MINUTES
**BOARD OF BUILDING STANDARDS/
ARCHITECTURAL BOARD OF REVIEW/SIGN REVIEW**
REVIEW MEETING
CITY OF LAKEWOOD
12650 DETROIT AVENUE
AUDITORIUM
JUNE 9, 2022
5:30 P.M.
RECORDING IS AVAILABLE
<https://www.lakewoodoh.gov/videos-2/>

Docket No. 05-60-21 (13314 Detroit)
Sign (Update) – Haber Family Center

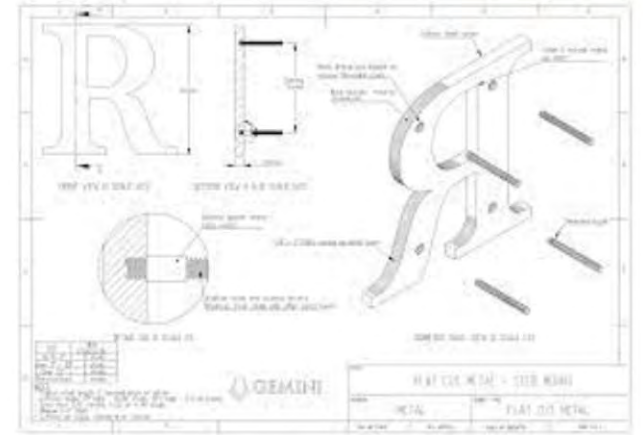
- Align the lettering with the brick lines.
- Clean the brick prior to installation.

Docket No. 1-2-22 (17000 Madison)
Sign (Update) – Gingham Market

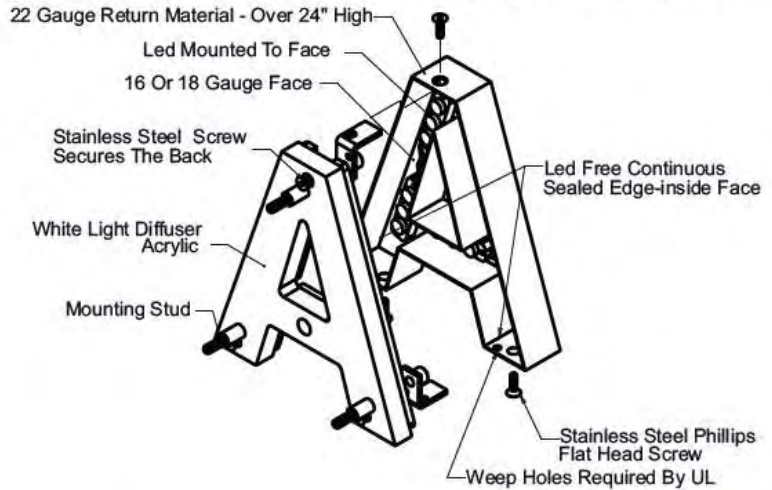
Approval Condition: Shift window graphic proposed for inside entryway to Winton side

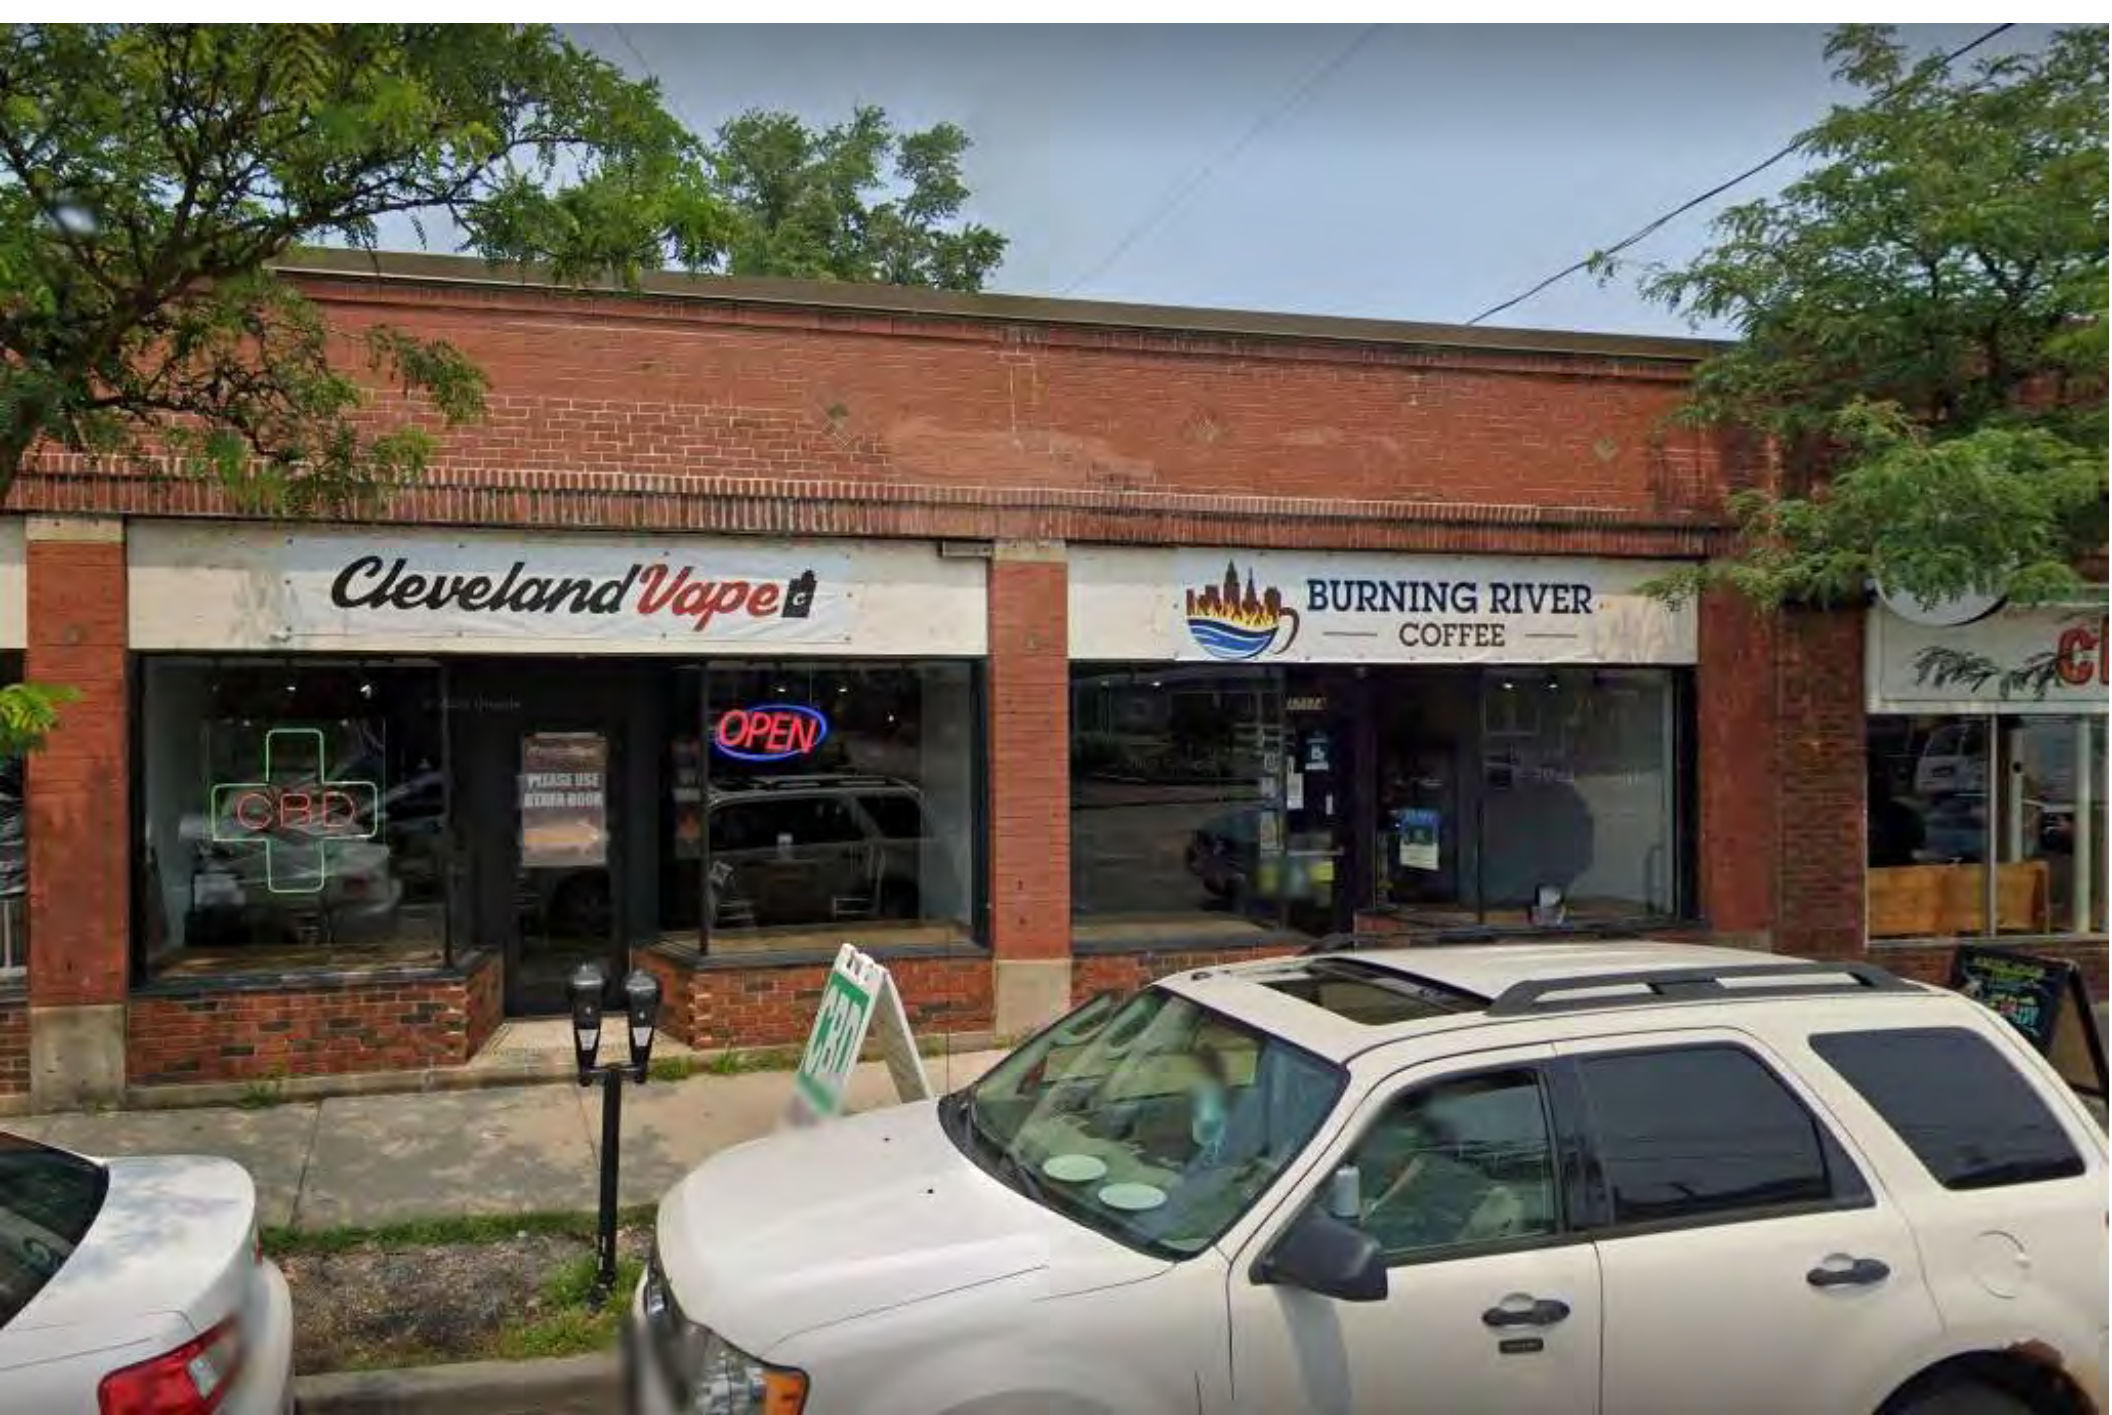
- Each storefront frontage of ~20 ft = ~30 ft² of total allowable sign area.
- “Cleveland Vape” proposal includes wall lettering (~12 ft²) with blade sign (~6 ft²) for installation.
- “Burning River” proposal includes wall lettering (~18 ft²) with blade sign (~6 ft²) for installation.
- Confirm if depicted “Burning River” window graphics are included..if so, provide dimensions.
- Confirm if blade signs are illuminated.
